DESIGN <i>[Signature]</i>	DRAWN BY <i>[Signature]</i>	DART AEROSPACE LTD HAWKESBURY, ONTARIO, CANADA	
CHECKED <i>[Signature]</i>	APPROVED <i>[Signature]</i>	DRAWING NO. DSI 9292	REV. A SHEET 1 OF 1
DATE 05.01.31		TITLE DOUBLER MODIFICATION	SCALE NTS
A	05.01.31	NEW ISSUE

DART SERVICE INSTRUCTION

TO AMEND INSTALLATION INSTRUCTIONS IIN-D412-698 REV. B OR REV. C

SEE SECTION A-A OF FIGURE 4
ON PAGE 8 OF IIN-D412-698
FOR REFERENCE

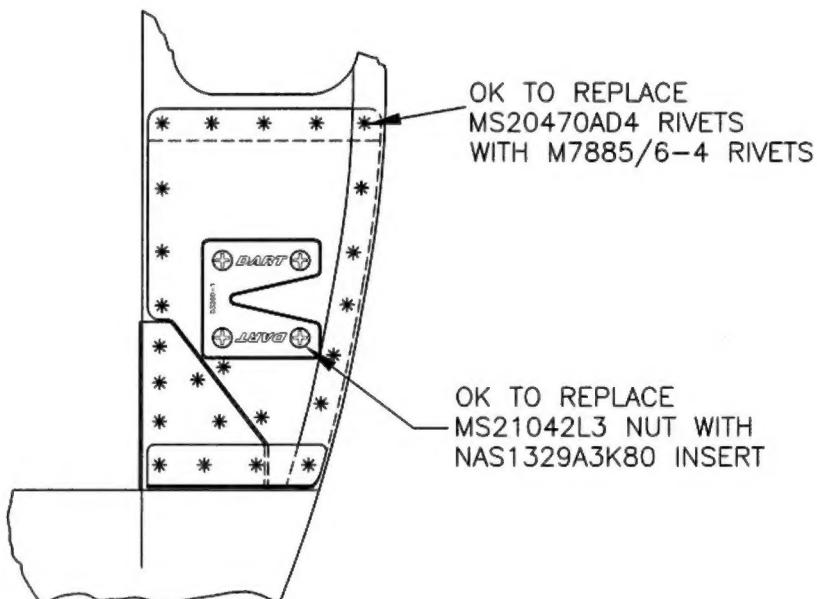
IT IS ACCEPTABLE TO PERFORM THE FOLLOWING DEVIATIONS WHEN INSTALLING THE D412-698-015 KIT ON 412CF AIRCRAFT:

- 1) TRIM THE D3201-1 DOUBLER AS SHOWN BELOW TO AVOID INTERFERING WITH THE TRIANGULAR SHAPED DOUBLER ON THE INSIDE CORNER.
- 2) REPLACE MS20470AD4 RIVETS WITH M7885/6-4 RIVETS.
- 3) REPLACE MS21042L3 NUTS WITH NAS1329A3K80 INSERTS INSTALLED THROUGH BOTH THE D3201-1 DOUBLER AND THE EXISTING SHEET METAL IN THE DOOR POST. DRILL Ø0.250"-0.256" TO INSTALL NAS1329A3K80 INSERTS.
